Executive Director's Recommendation

Commission Meeting: July 9, 2026

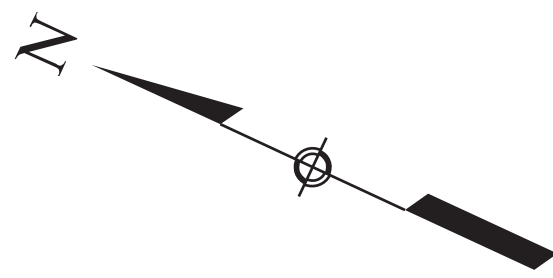
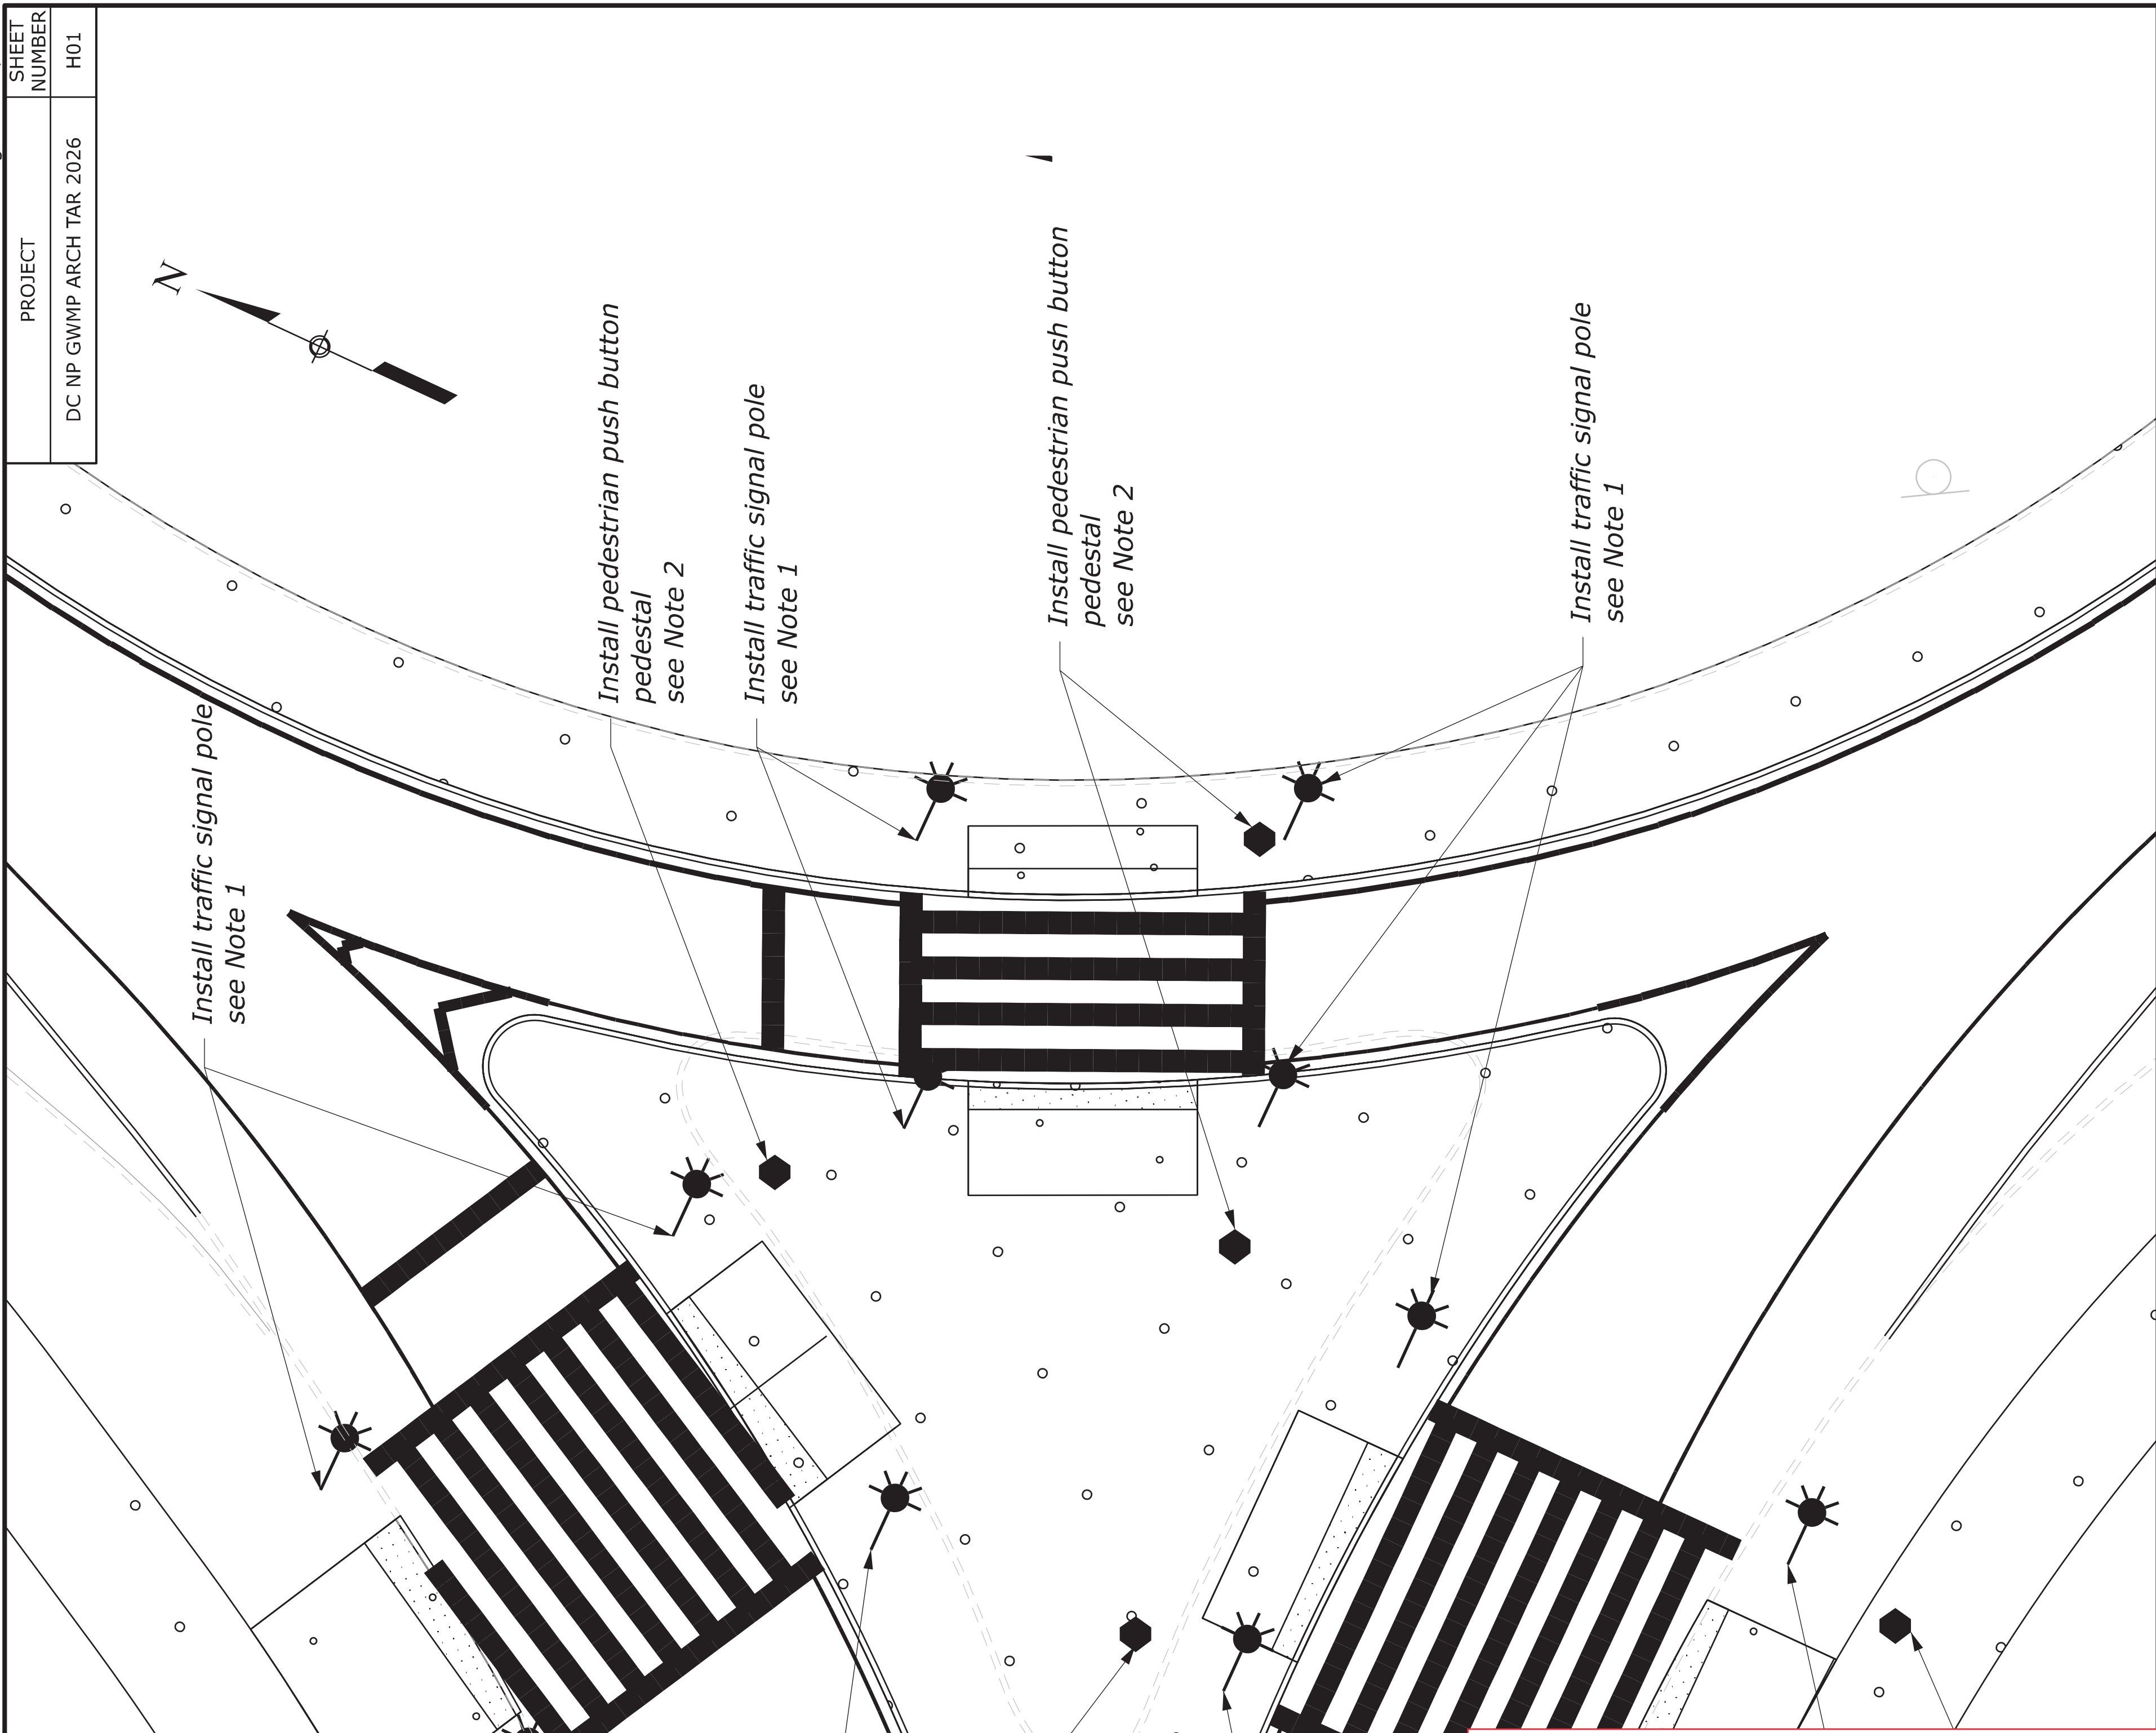
General Comments:
